SUBJECT: ST. LUCIE UNIT 2 - ISSUANCE OF AMENDMENT RE: PRESSURE/TEMPERATURE LIMITS AND LOW TEMPERATURE OVERPRESSURE PROTECTION (TAC NO. 76016)

AMENDMENT NO. 46 TO FACILITY OPERATING LICENSE NO. DPR-67 - ST. LUCIE, UNIT 1

ATTACHMENT TO LICENSE AMENDMENT NO. 46
TO FACILITY OPERATING LICENSE NO. NPF-16
DOCKET NO. 50-389

**FIGURE 3.4-2
ST. LUCIE-2 P/T LIMITS, 15 EFPY
HEATUP AND CORE CRITICAL**

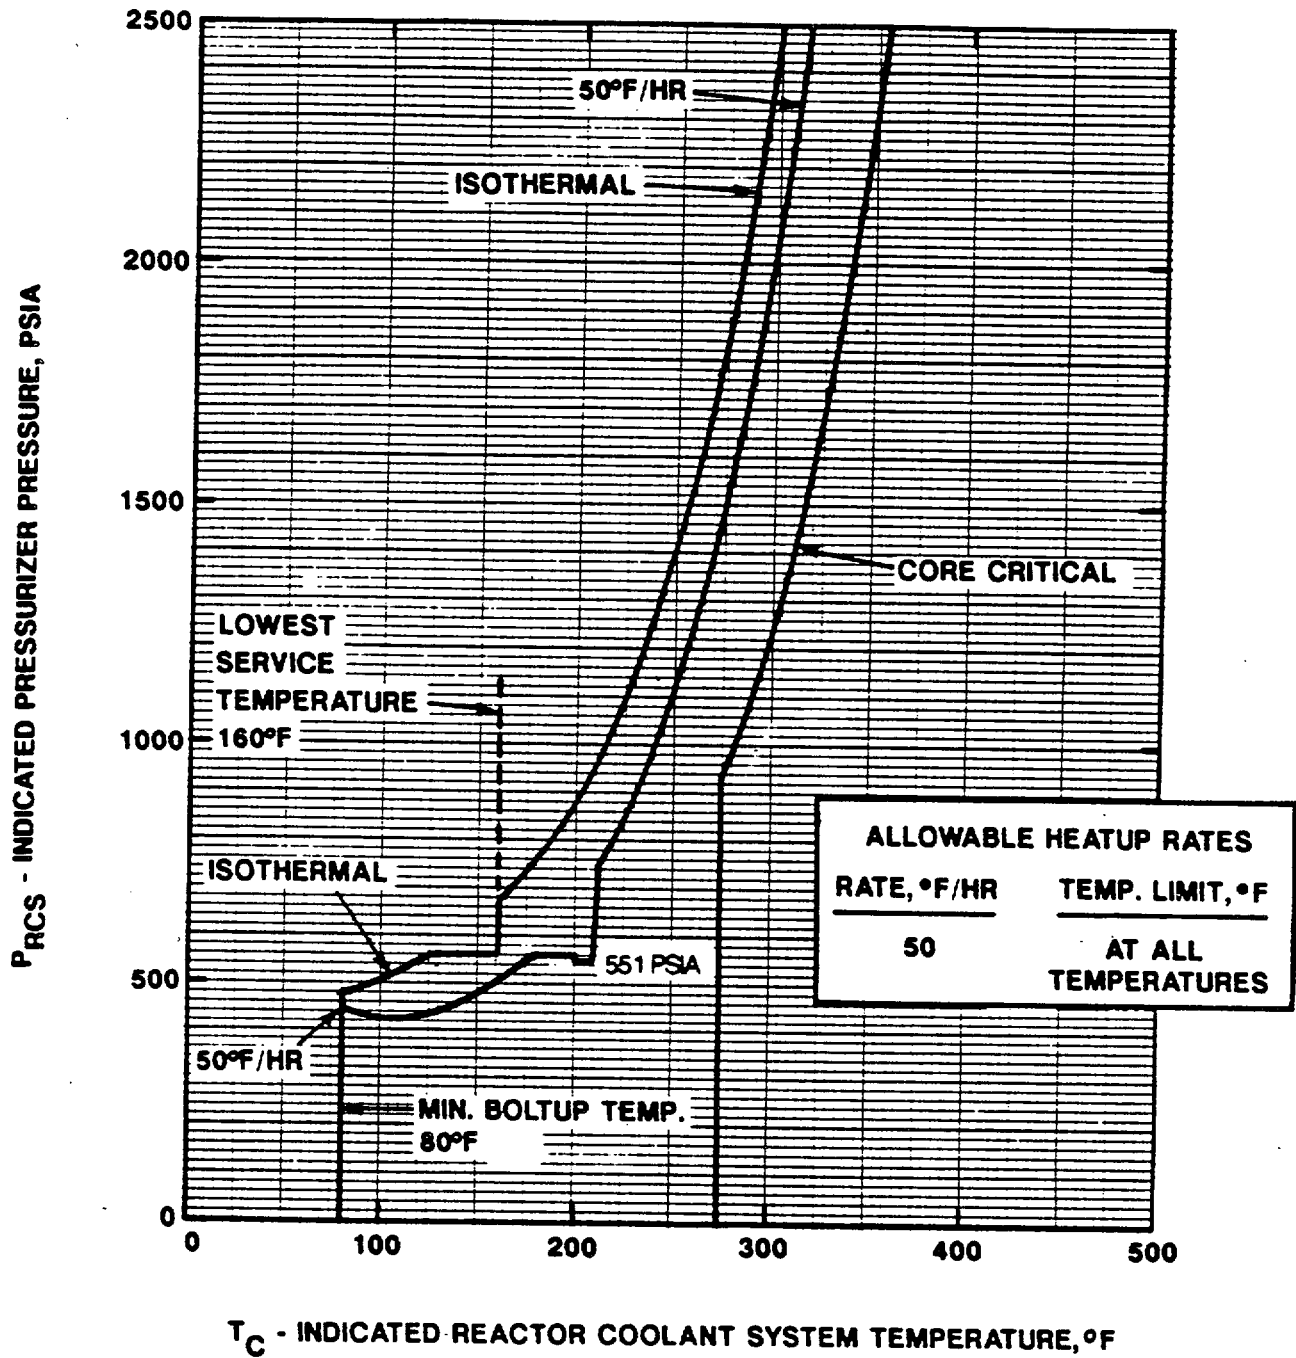
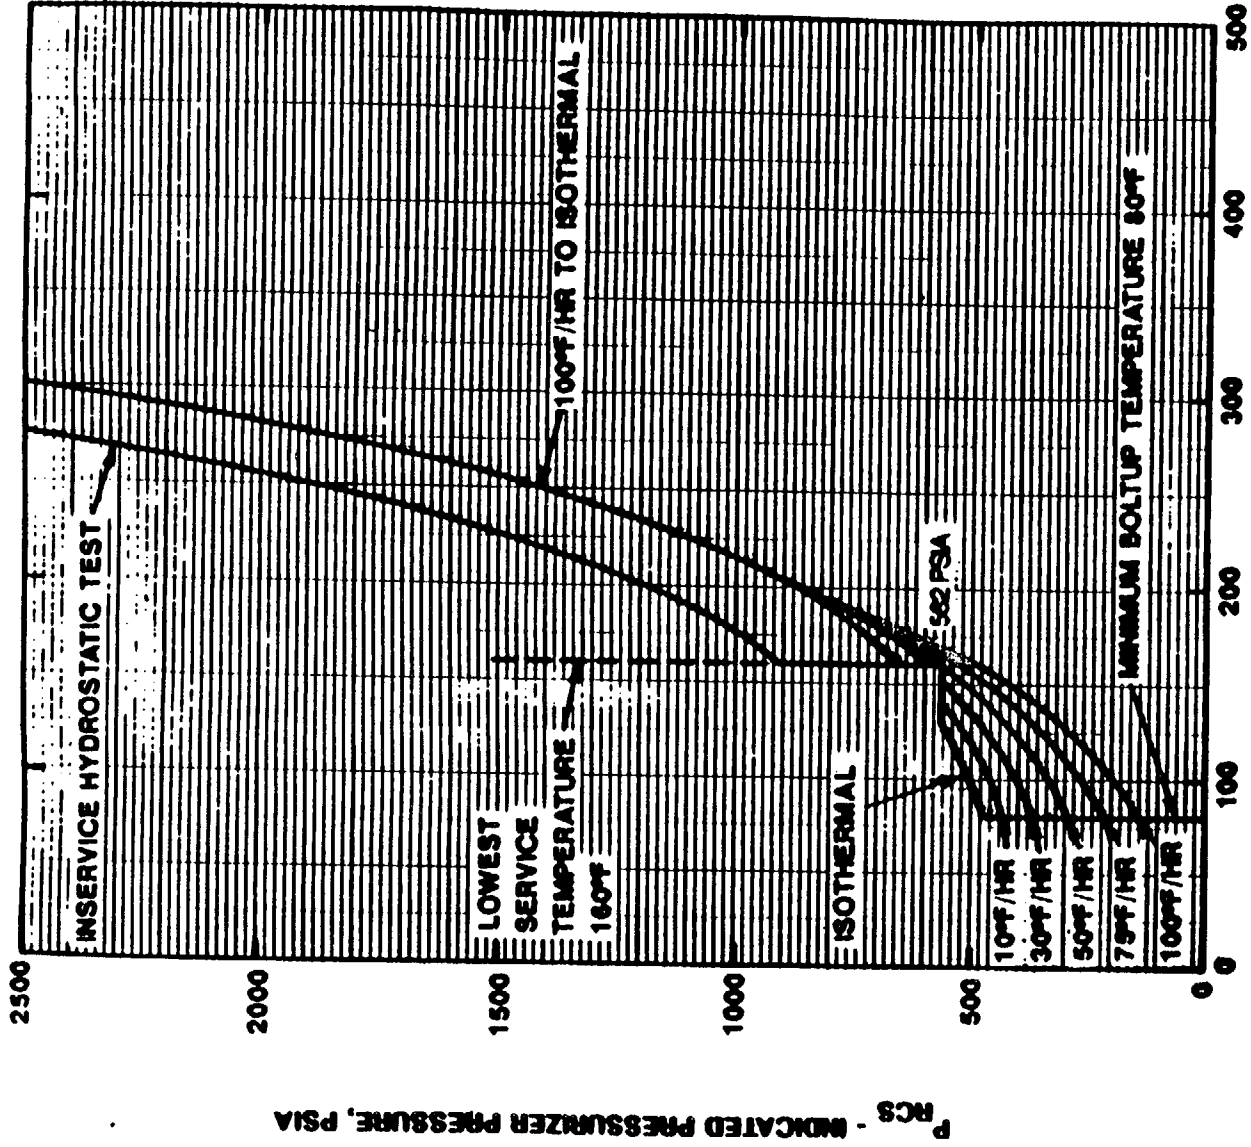
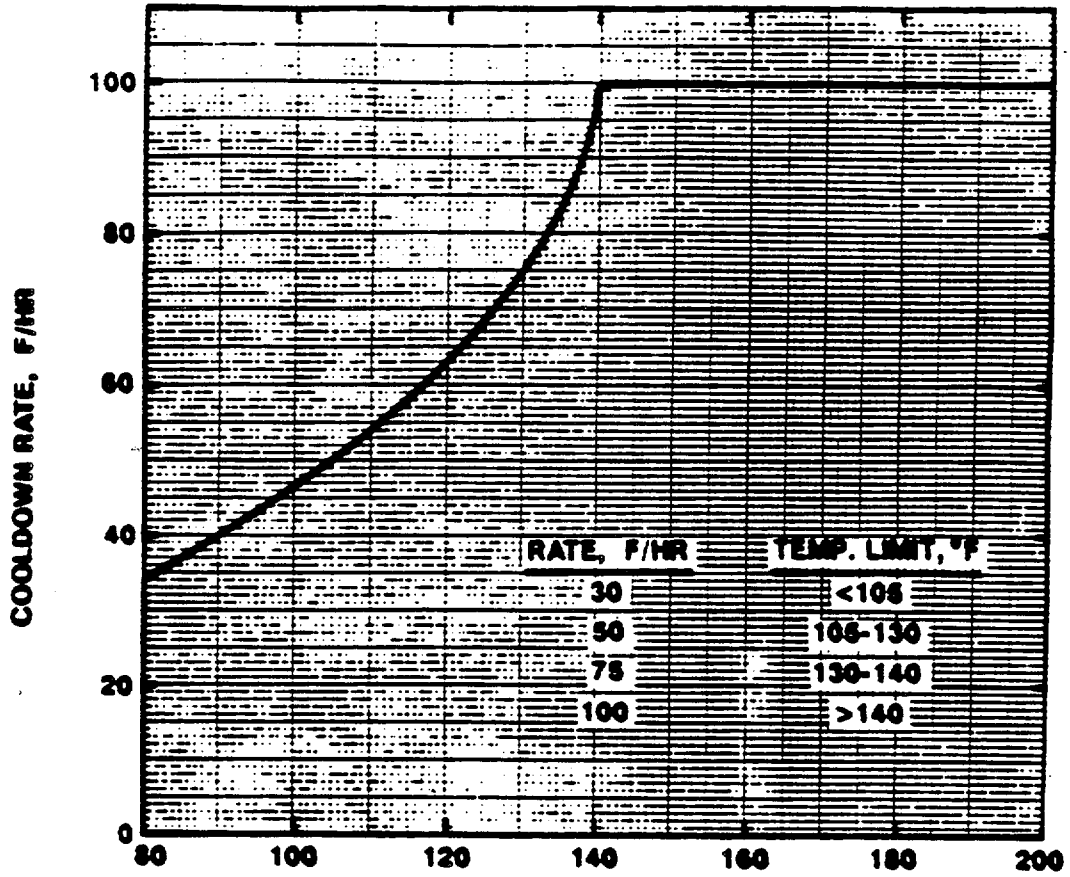
The RCS P/T limits during plant heatup and cooldown are specified in TS Figures 3.4-2 and 3.4-3 for St. Lucie Unit 2. The P/T curves in the current TS are based on an assumed design basis neutron fluence through 6 EFPY.

By letter dated February 7, 1990, as supplemented June 19, 1990, the licensee provided its updated P/T curves in proposed TS Figures 3.4-2 (for heatup and core critical) and 3.4-3 (for cooldown and inservice testing), revised cooldown rates as a function of indicated reactor coolant temperature in proposed Figure 3.4-4, changes in the values of the RCS cold leg temperature at which LTOP should be enabled, and the justification for the changes. The new P/T curves are based on the irradiation damage prediction methods of RG 1.99, "Radiation Embrittlement of Reactor Vessel Materials," Revision 2, U.S. Nuclear Regulatory Commission, May 1988, and are applicable for a period up to 15 EFPY.

The licensee-proposed changes in TS 3.4.9.3, Tables 3.4-3 and 3.4-4, and the associated Bases sections reflect the above discussed LTOP alignment temperatures and the heatup and cooldown rates identified by the updated Figures 3.4-2, 3.4-3, and 3.4-4 in TS 3.4.9.1. The staff finds that they are based on applicable regulatory guidance in Standard Review Plan (SRP) 5.2.2, Revision 2, are reasonably conservative, and are acceptable.

LCO 3.4.9.1 is revised to make reference to the updated Figures 3.4-2, 3.4-3 and 3.4-4. These changes are judged to be administrative in nature and are acceptable.

3.4.9.1 The Reactor Coolant System (except the pressurizer) temperature and pressure shall be limited in accordance with the limit lines shown on Figures 3.4-2, 3.4-3 and 3.4-4 during heatup, cooldown, criticality, and inservice leak and hydrostatic testing.

The heatup and cooldown limit curves Figures 3.4-2, 3.4-3 and 3.4-4 are composite curves which were prepared by determining the most conservative case, with either the inside or outside wall controlling, for any heatup rate of up to 50 degrees F per hour or cooldown rate of up to 100 degrees F per hour. The heatup and cooldown curves were prepared based upon the most limiting value of the predicted adjusted reference temperature at 15 EFPY, and they include adjustments for pressure differences between the reactor vessel beltline and pressurizer instrument taps.
